# Access Compliance Report

## Public Rights-of-Way

### (Curb Ramps)

Intersection ID: 25496	Main Street: GRIMMERSBOROUGH_LN	Cross Street: PROVIDENCE_PLANTATION_LN	Location: NW
ADA ID: 6700DB3FBD27	Ramp Type: Perp	Initial Pass/Fail: Fail	Overall Compliance: No
Severity Score: 21.25			
Codes/Mitigation Info/Possible Solution		Field Measurements/Component Compliance

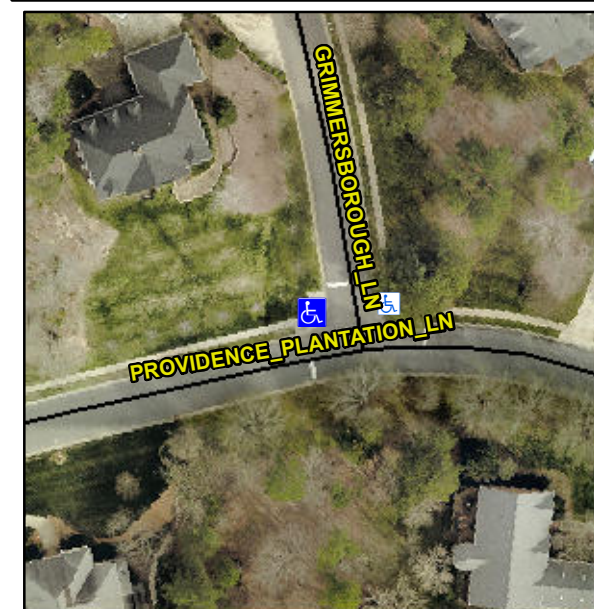
**Not Found, R304.5.1, R304.5.3**

Compliance	Description	Data	Compliance	Description	Data
N/A	Ramp Length (in)	49.5	Yes	Ramp Slope (%)	6.8
No	Ramp Width (in)	46.5	No	Ramp XSlope (%)	5.1
N/A	Flare Type LT	N/A	N/A	Flare Type RT	N/A
N/A	Flare Slope LT (%)	N/A	N/A	Flare Slope RT (%)	N/A
N/A	Flare Traversable LT?	N/A	N/A	Flare Traversable RT?	N/A
N/A	Landing Length (in)	N/A	N/A	DWS Provided?	N/A
N/A	Landing Width (in)	N/A	N/A	DWS Contrast?	N/A
N/A	Landing Slope (%)	N/A	N/A	DWS Length (in)	N/A
N/A	Landing X Slope (%)	N/A	N/A	DWS Full Width?	N/A
N/A	Landing Curb? (Y/N)	N/A	N/A	DWS Offset (in)	N/A
N/A	Shared Landing?	N/A			
N/A	Gutter Ponding?	N/A	N/A	Gutter Slope (%)	N/A
N/A	Gutter Lip Ht (in)	N/A	N/A	Gutter X Slope (%)	N/A
N/A	Painted X Walk1?	No	N/A	Painted X Walk2?	N/A
	X Walk 1 Direction	To E		X Walk 2 Direction	N/A
N/A	X Walk 1 Width (in)	N/A	N/A	X Walk 2 Width (in)	N/A
	X Walk 1 Slope (%)	1.1		X Walk 2 Slope (%)	N/A
	X Walk 1 X Slope (%)	6.0		X Walk 2 X Slope (%)	N/A

**Remove & Replace Entire Ramp.**
